LINCOLN CITY/LANCASTER COUNTY PLANNING STAFF REPORT

for October 27, 2004 PLANNING COMMISSION MEETING

P.A.S.: Four Stones Community Unit Plan
Co. Special Permit #04055, Preliminary Plat #04025

PROPOSAL: A community unit plan and preliminary plat for thirty one acreage residential units.

PAVING
PROFILES

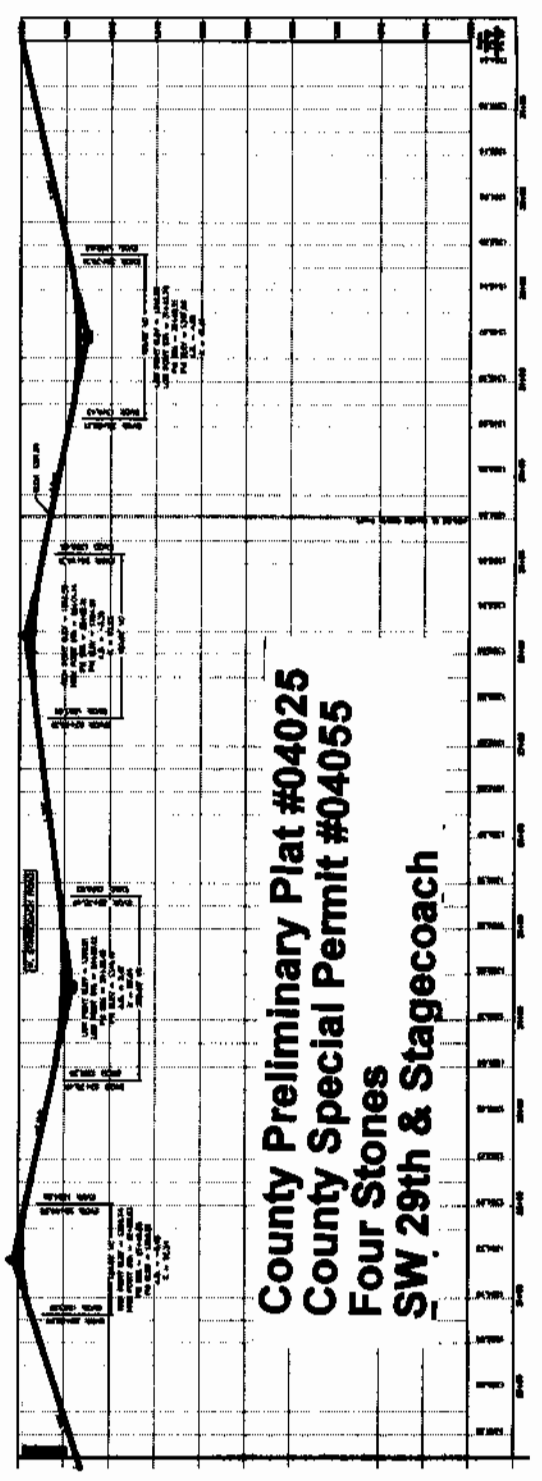
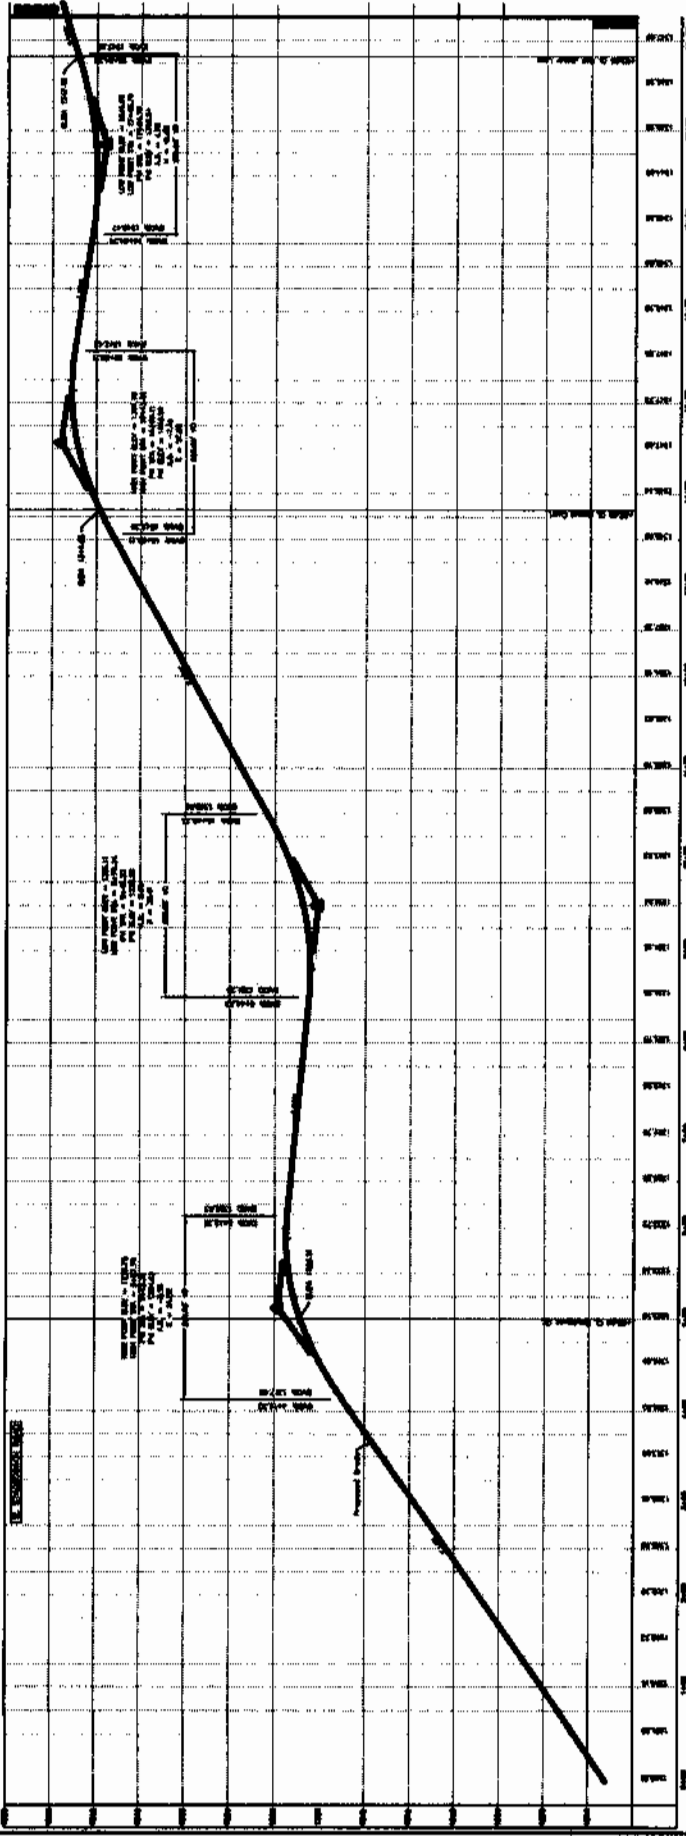
12) The break in grade at Sta. 2 + 75 on Garnett Court should have a vertical curve.

13) The sight distance for Red Jasper Lane to the east on West Stagecoach Road is below the minimum.

14) The sight line for Garnet Court to the east on West Stagecoach Road goes across a low point in West Stagecoach Road that could hide the majority of an oncoming vehicle.

16) The profile of Sandstone Circle does not allow the twin 30" culverts to fit under the roadway.

County Preliminary Plat #04025
County Special Permit #04055
Four Stones
SW 29th & Stagecoach

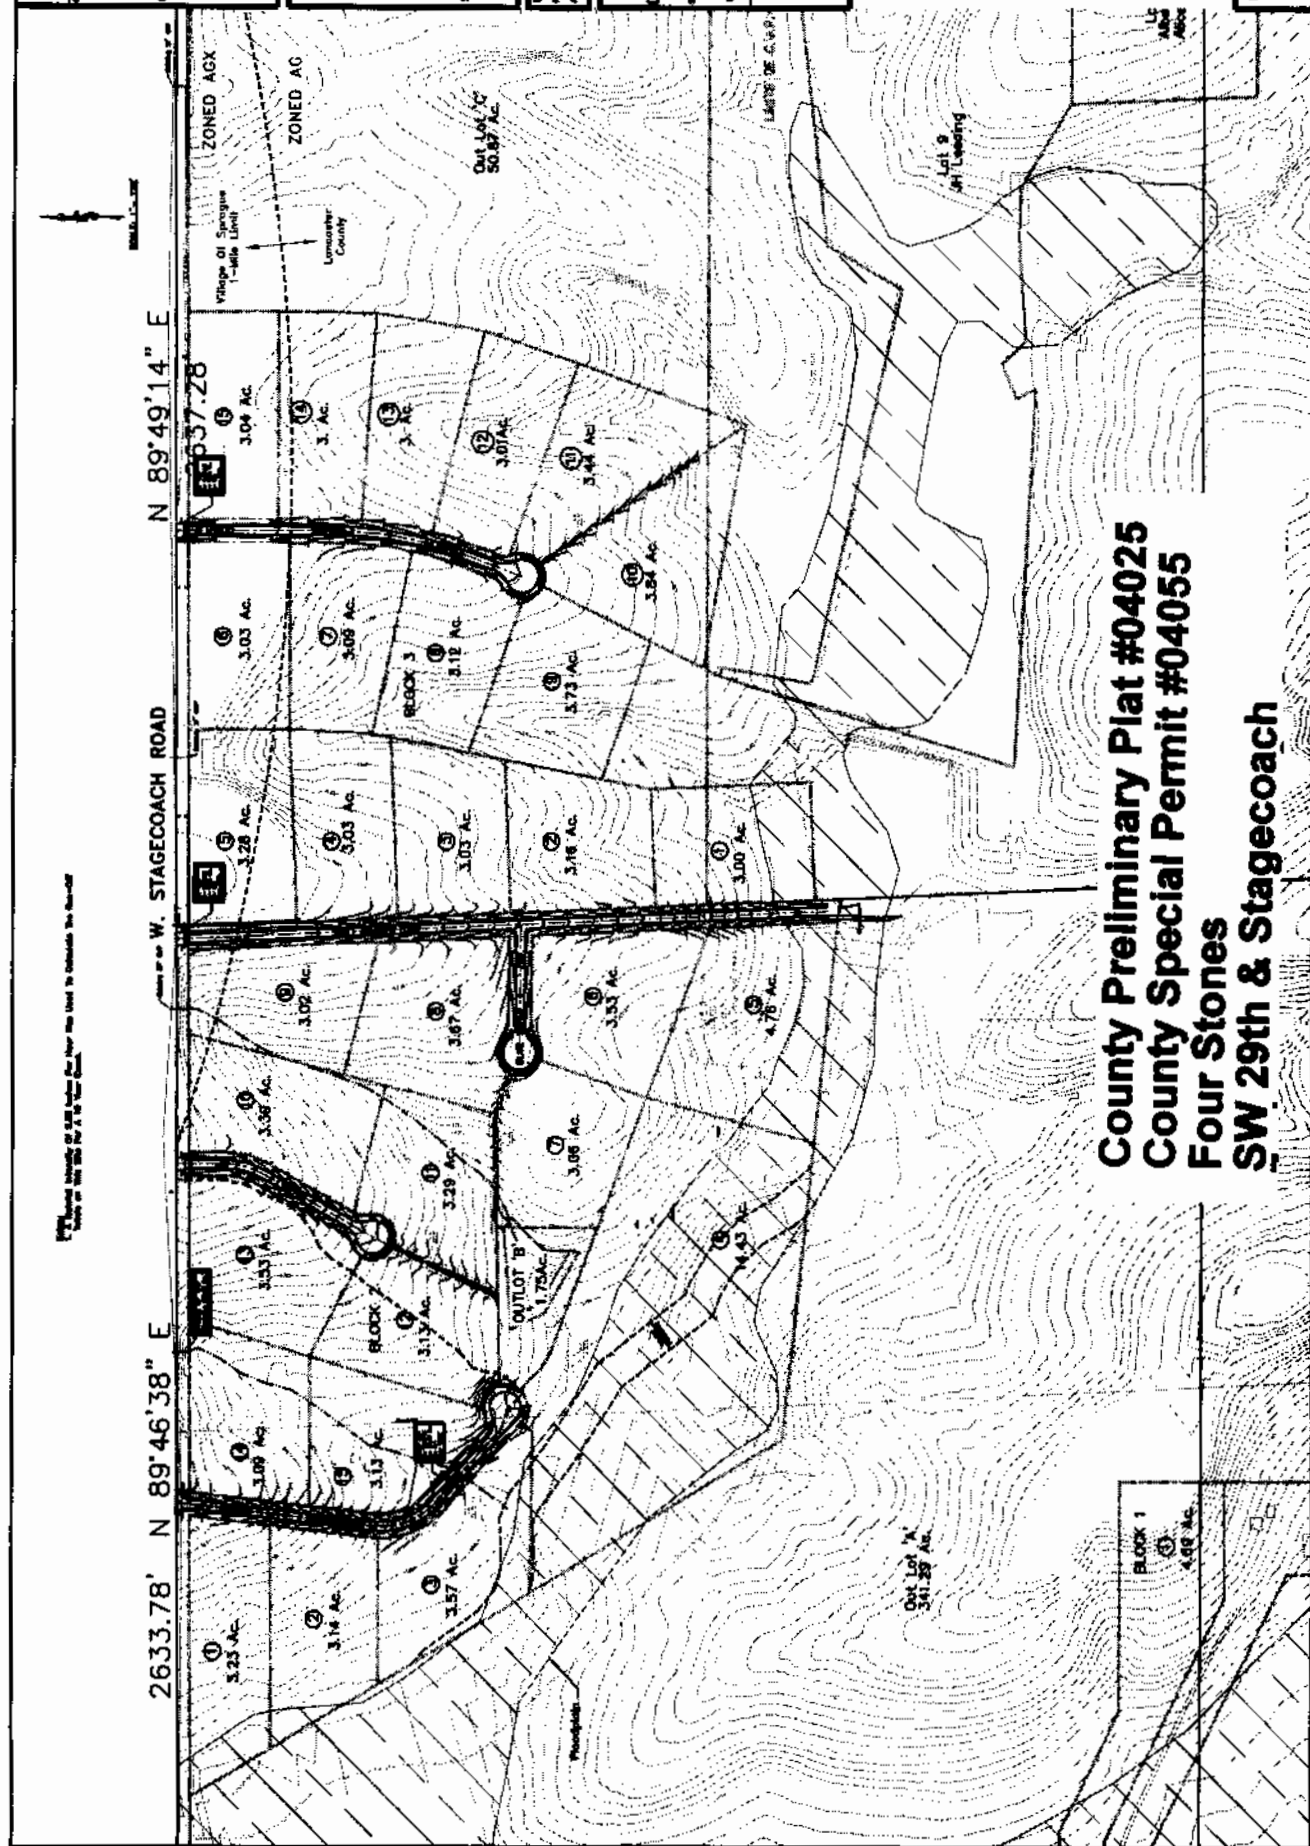
3) Redesign layout to eliminate two street intersections to West Stagecoach Road. Provide for an internal flow of traffic.

6) General Note No. 10 shall identify the number of farm accesses, and shall detail access relinquishment on SW 29th Street, SW 14th Street and West Panama Road.

8) The lot south of Lot 1 needs a lot number (this is outside the plat and will require a separate county subdivision permit). There is nothing separating Block 1 and Block 2. They should be combined into one block.

10) Type III barricades, 22.00 feet long shall be placed at the end of Red Jasper Lane.

- 1.2 Revise the drawing to show a vicinity/sketch map.
- 1.3 Revise the street names to remove conflicts with existing streets names.
- 1.4 Show uses of the Outlots.

- 1.5 Show 120 feet of county road right-of-way and a 60' dedication.
- 1.6 Clearly show the boundaries of the CUP.
- 1.7 Do a subdivision for the existing farmstead split on S.W. 29th Street. Approval will be required prior to final platting.
